**STAFF REPORT:** 10-14-2020 MEETING

**APPLICATION NUMBER:** #20-6894

**ADDRESS:** 1991 CHICAGO

**SCOPE:** DEMOLITION / REPAIR WORK OF FRONT PORCH (WORK DONE WITHOUT PERMIT)

Figure 1 Applicant Scope of Work

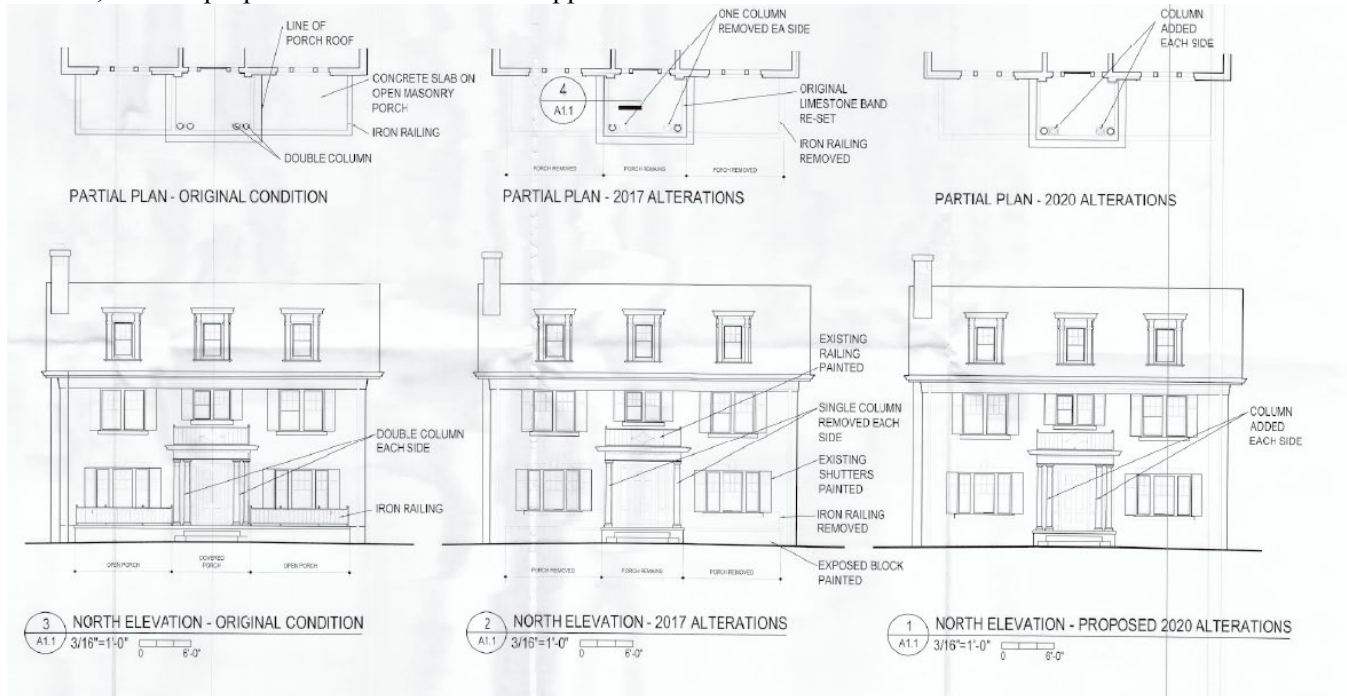
- Front porch surface, limestone edge, steps and brickwork
- There is a discrepancy between the application material and what was reported to staff. While the application material shows that the two columns that remain are described as original wood material, staff received confirmation these two remaining columns are actually the new, proposed composite material that is proposed to be duplicated to bring the total to 4 columns at the front side of the porch.

- The proposed composite column additions would generally bring the porch back to its original appearance, concerning column number and configuration, if the applicant uses the material as described in the attached cut-sheet.

- The Boston Edison neighborhood has a number of properties that feature the full-width, winged-porch front entrances and it is staff’s opinion that the former full-width porch was a character-defining feature of the home. The alteration of removing, rather than replacing the winged front porch has altered the character of this façade.

- The remaining wall surface below the first-story windows at the front elevation reveals brick-colored painted scars, which resulted from the removal of the porch base. This wall finish does not match the material composition of the brick wall, nor does it match the *relationship of textures*, as described in the Elements of Design for the Boston Historic District.

- The work undertaken at/proposed for the front porch to include the removal of the side wings and railing at the deck
- The current treatment of the "scars" at the front elevation wall surface below the first-story windows which resulted from the unapproved porch deck removal/replacement

Finally, if the Commission does approve the porch as it remains in its existing condition, without the side deck extensions, staff does recommend that the body do so with the condition that the exterior wall surface "scars" that flank the front porch be repaired by installing brickwork that matches the existing in scale, color, texture and mortar composition.

PARTIAL PLAN - ORIGINAL CONDITION

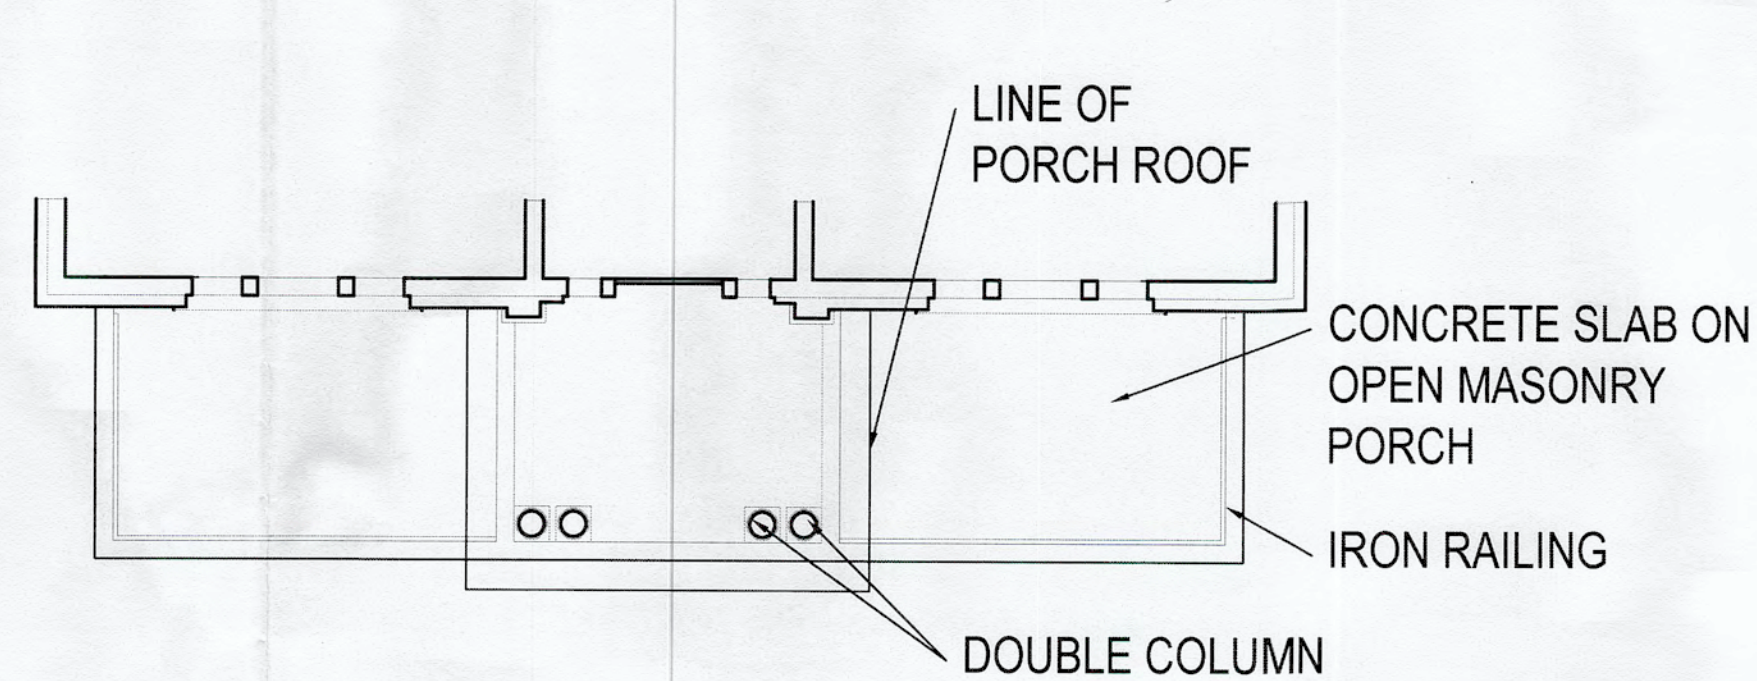
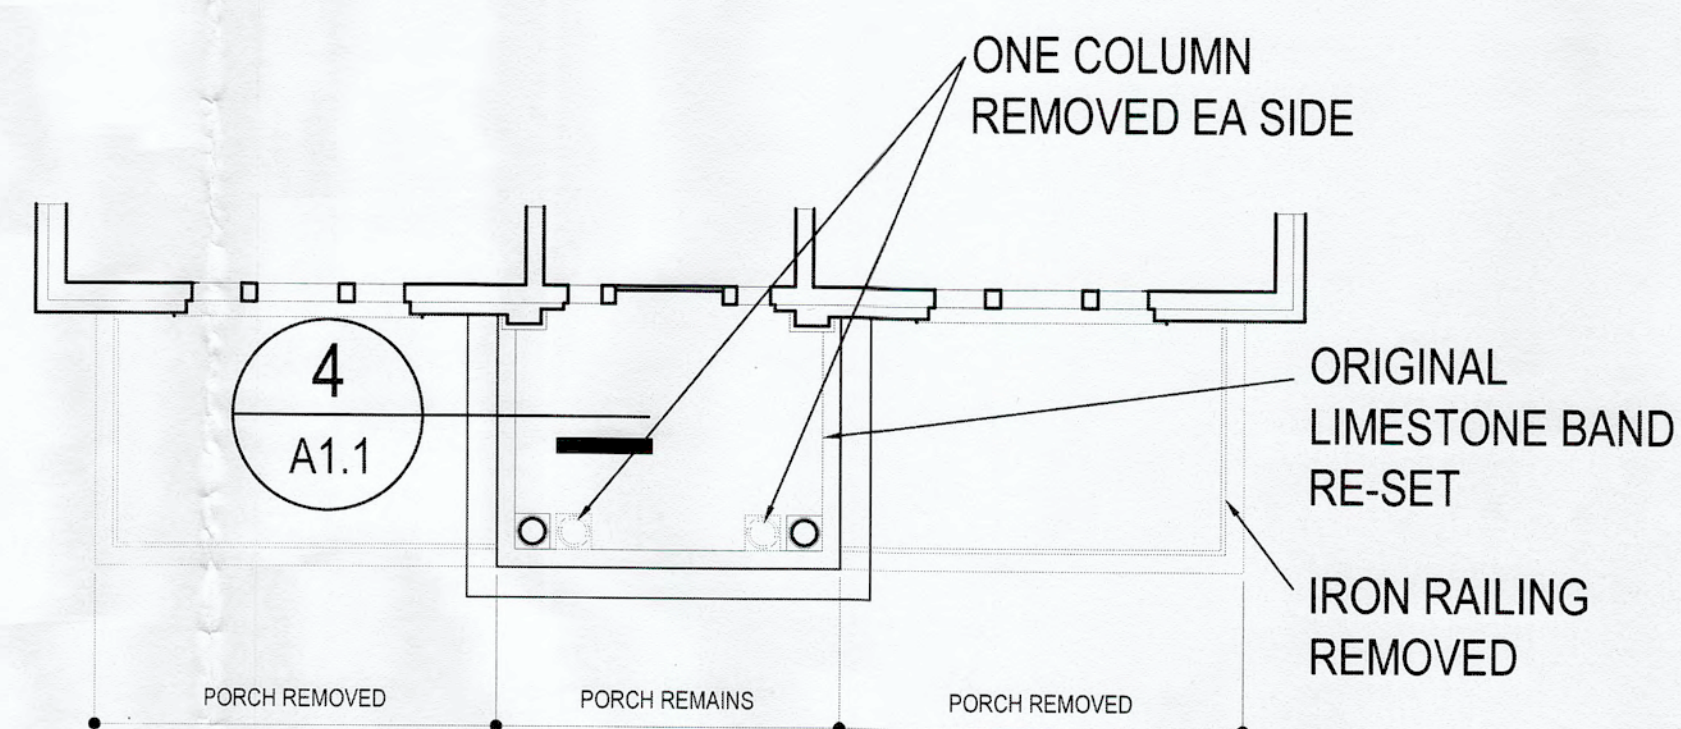
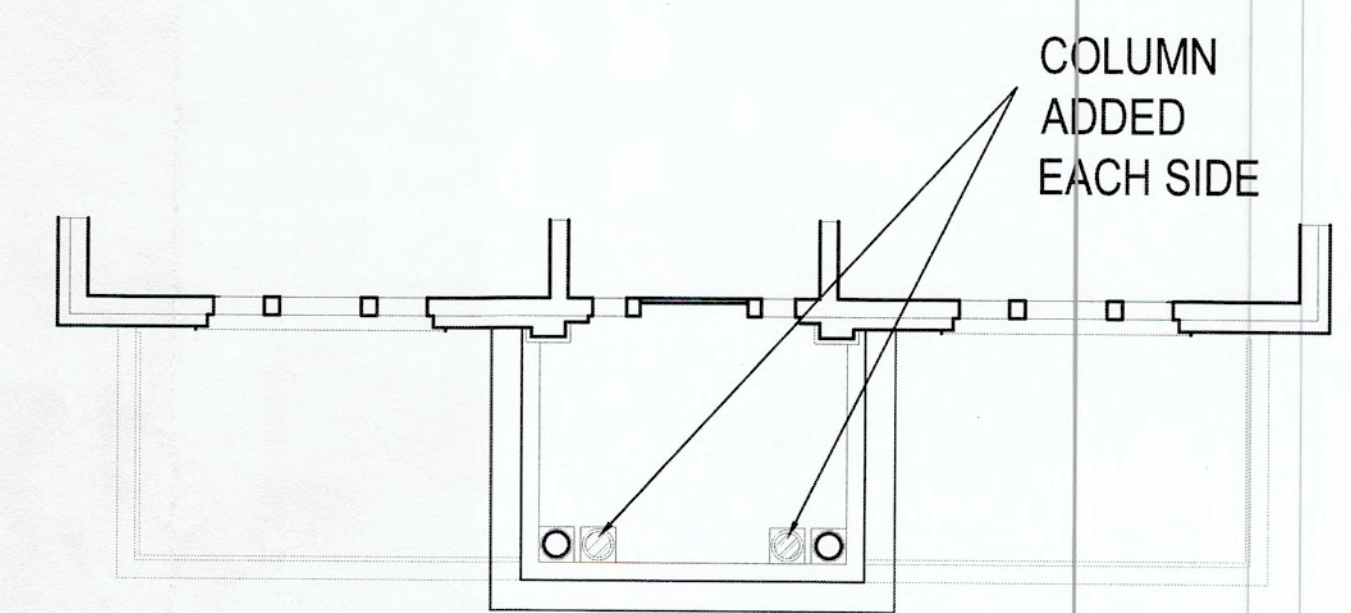
- As previously noted, it is staff's opinion that the former full-width porch was a character-defining feature of the home. The alteration of removing, rather than replacing the winged front porch has altered the character of the home's primary façade. Therefore, the current porch deck (sans the side extensions) does not conform to the Standards.
- The proposal fails to address the remaining "scars" at the front elevation, which resulted from the unapproved removal of the porch side wings. It is staff's opinion that the scale, design, color and location of the remaining scars does not conform to the distinctive features or finishes of the property, and therefore are in conflict with the Elements of Design of the Boston Edison Historic District and detracts from the building's historic appearance.
